ADDENDUM NO. 1 TO THE SPECIFICATIONS AND CONTRACT DOCUMENTS

City Project No. WTR25002

CROWN RD. TRANSMISSION MAIN

November 3, 2025

SHEET: C-4 OF: 6

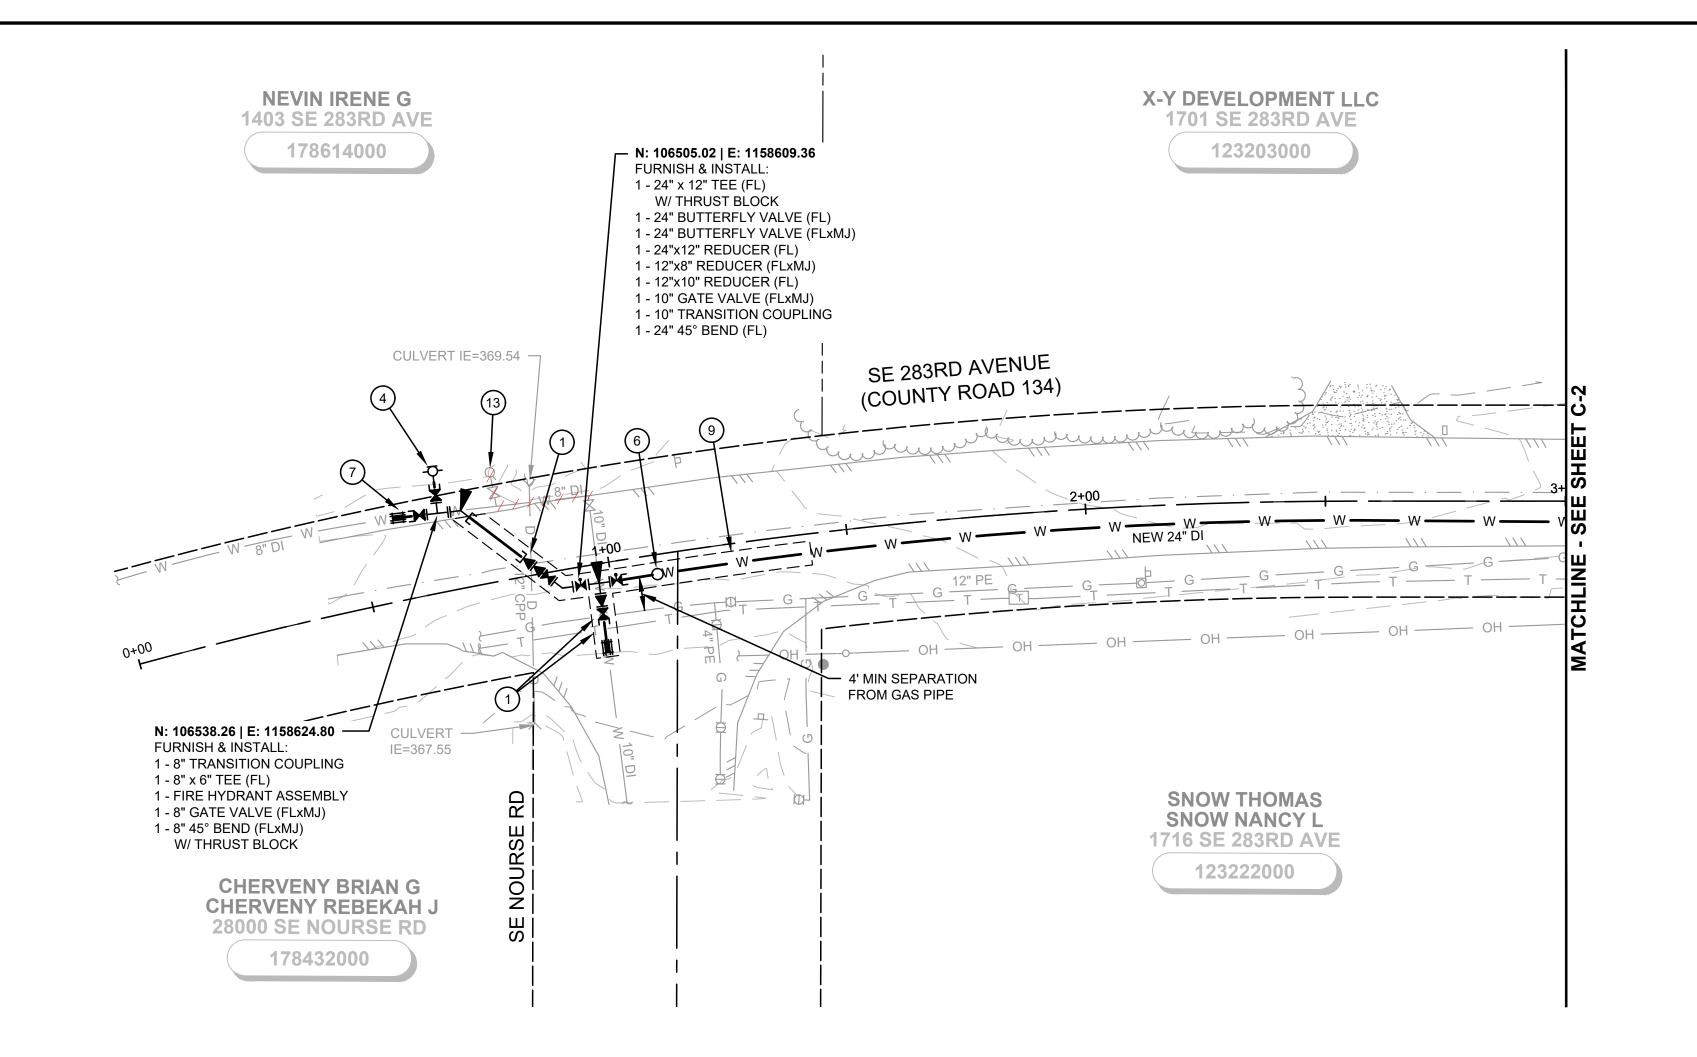
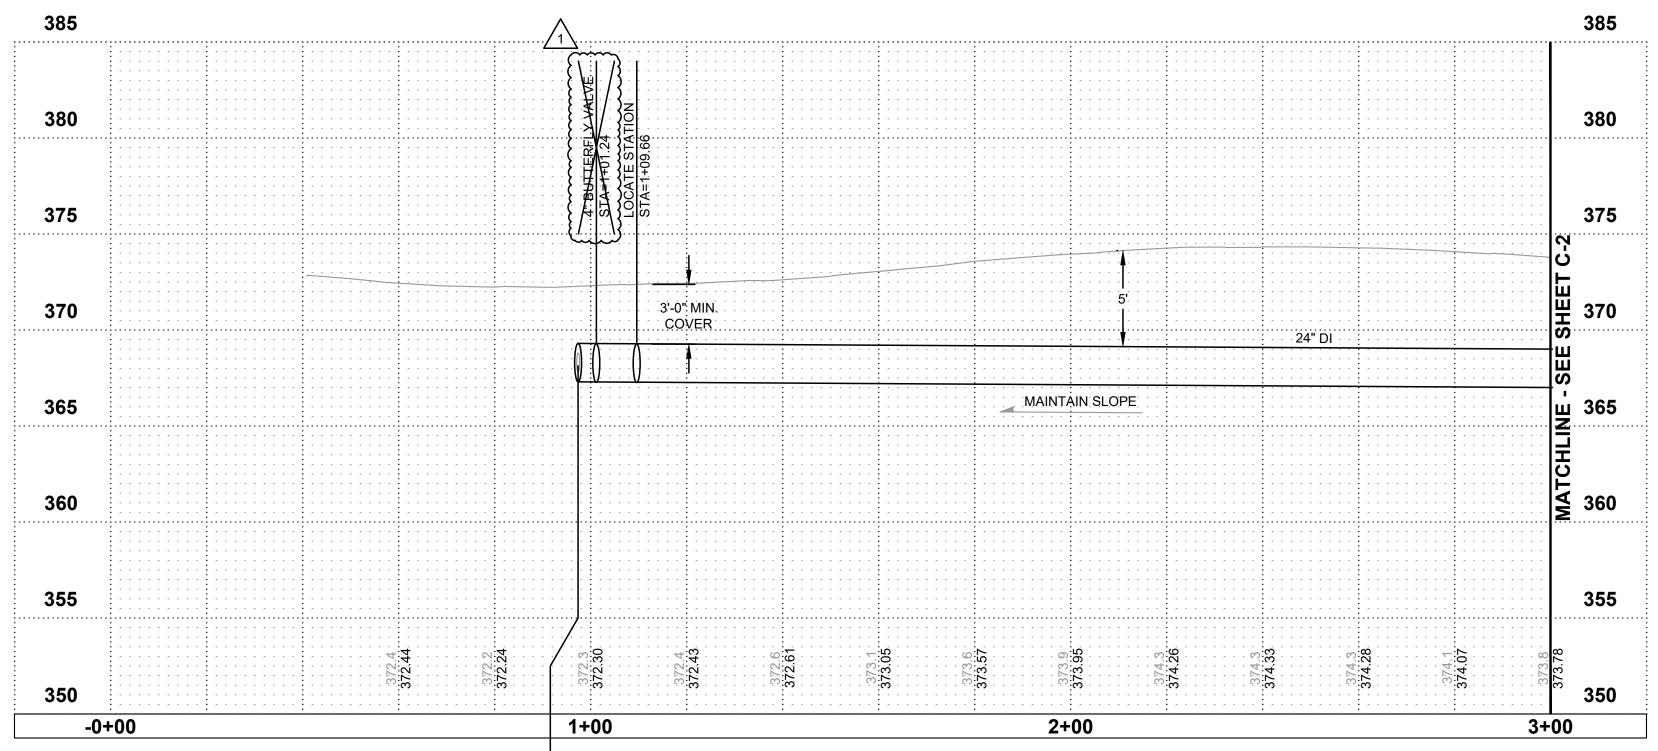
SHEET C-4

On plan, DELETE call out 6 LOCATE STATION

C-1 of: 6

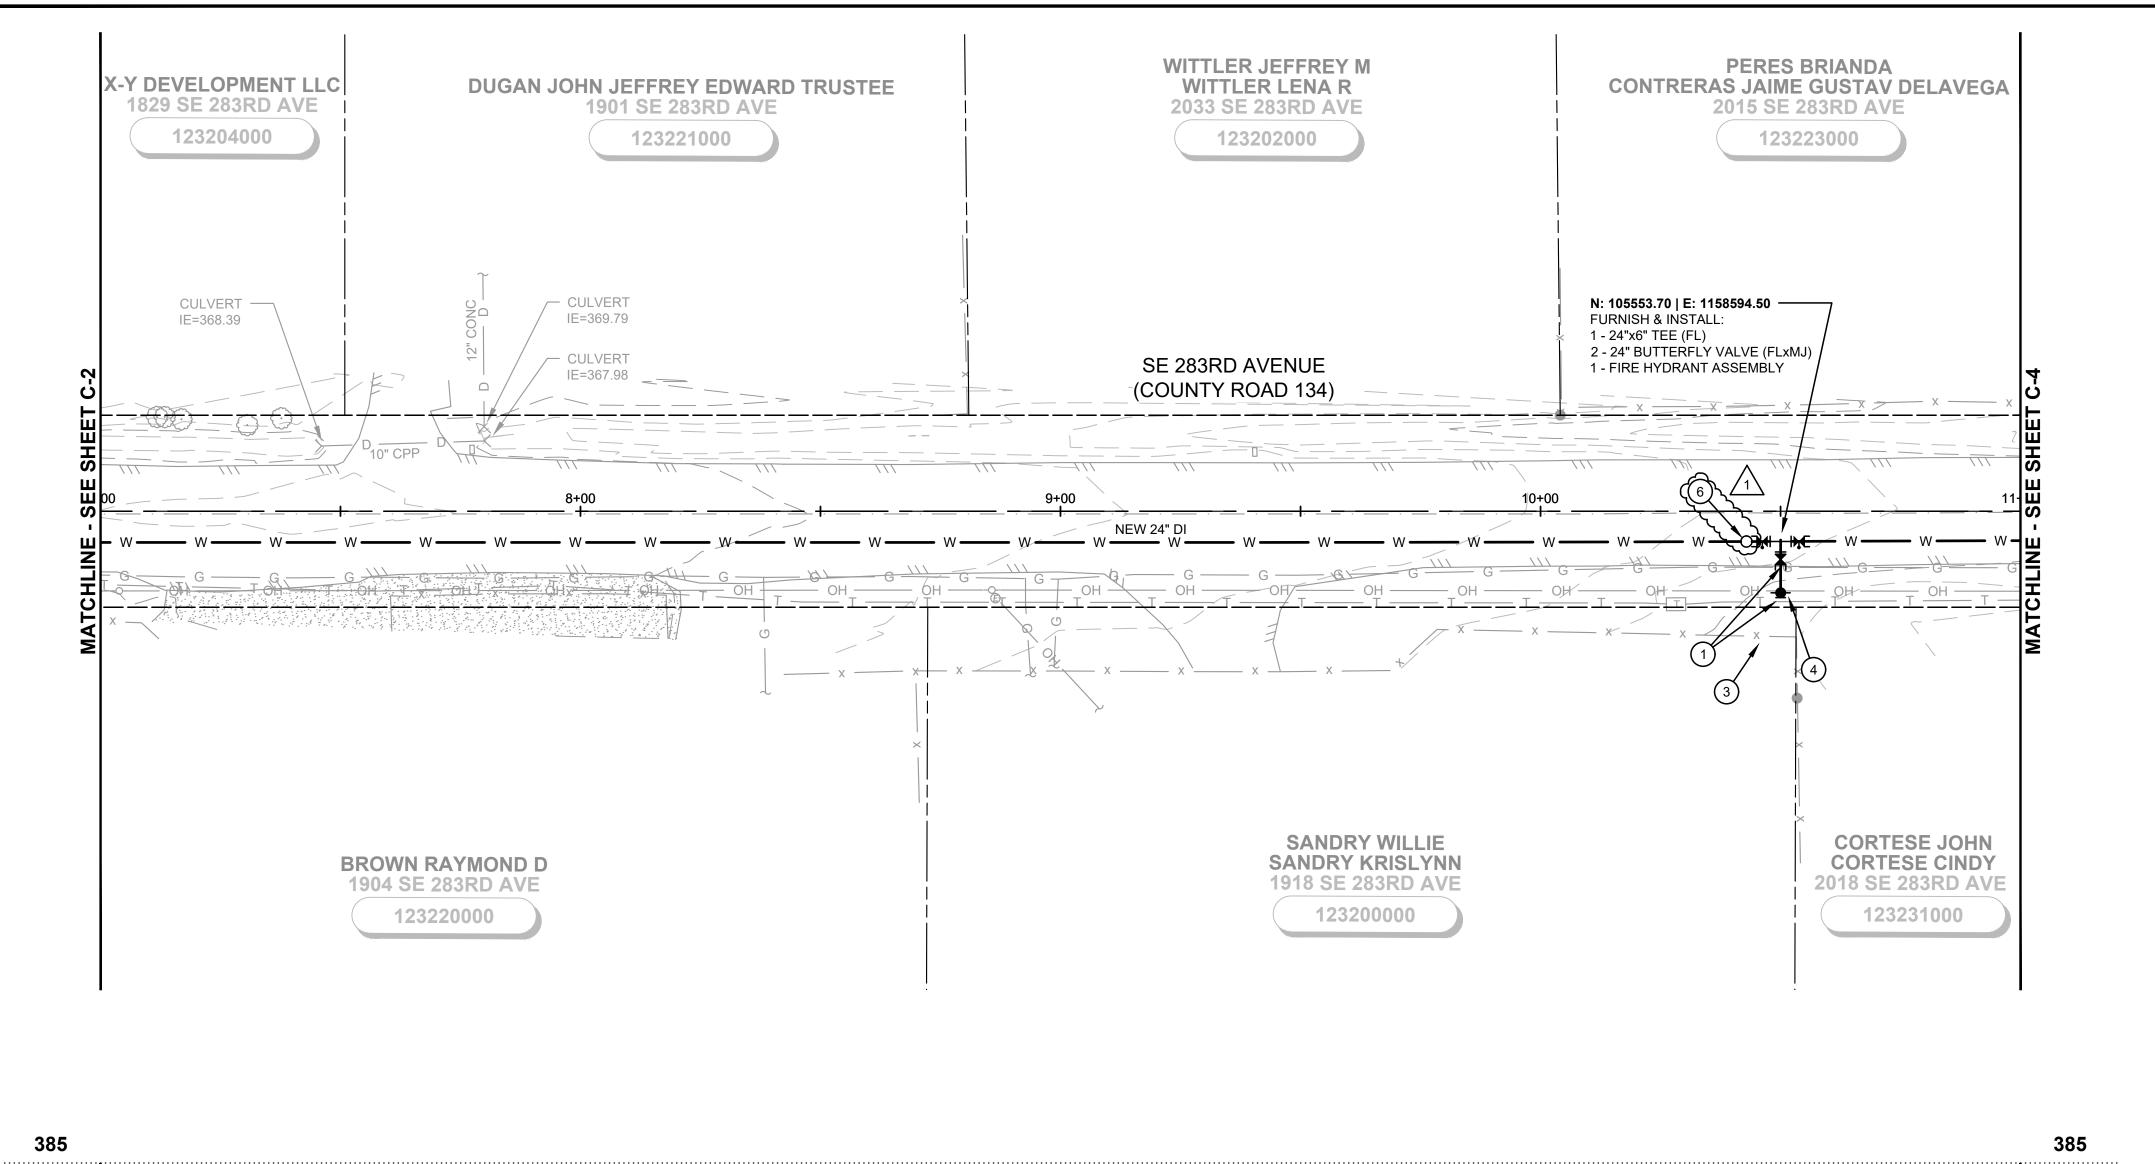
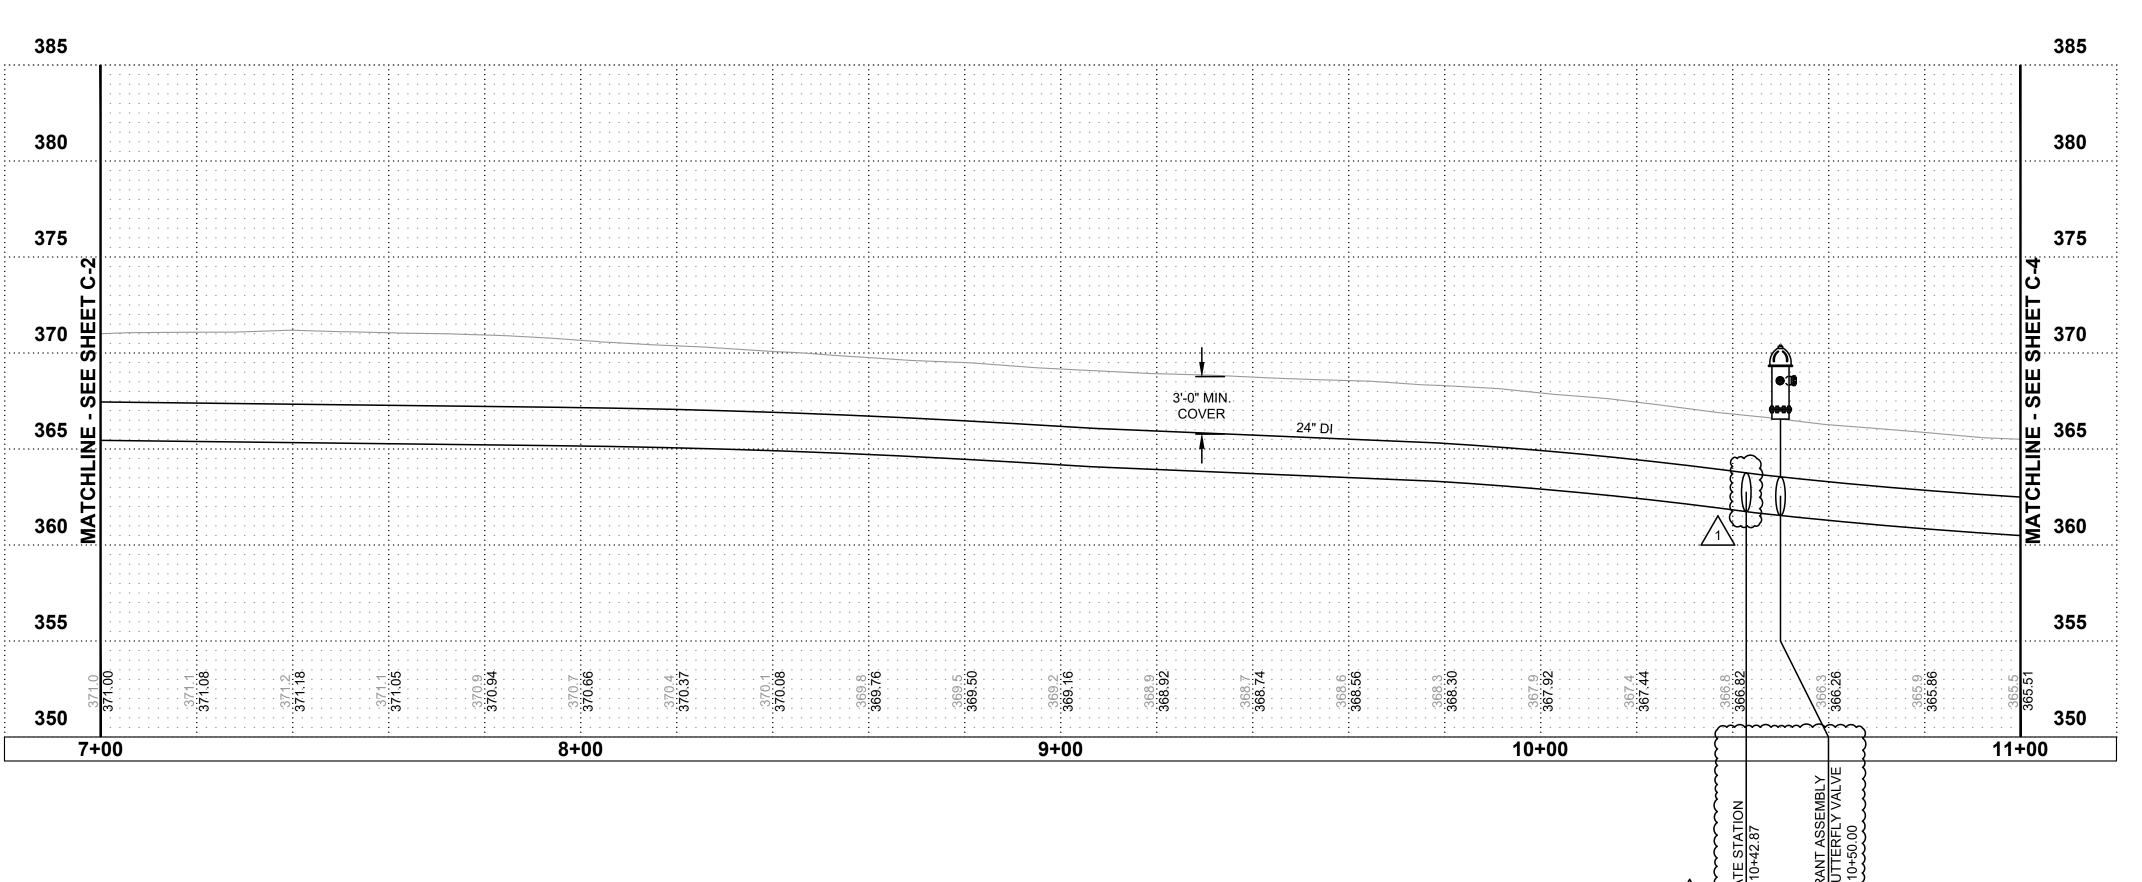
SHEET C-1

On profile, DELETE STA=1+01.24 call out 4" BUTTERFLY VALVE

SHEET C-1

On profile, ADD call out at STA=0+97.25, 4.00' RT 24" x12" TEE W/ THRUST BLOCK
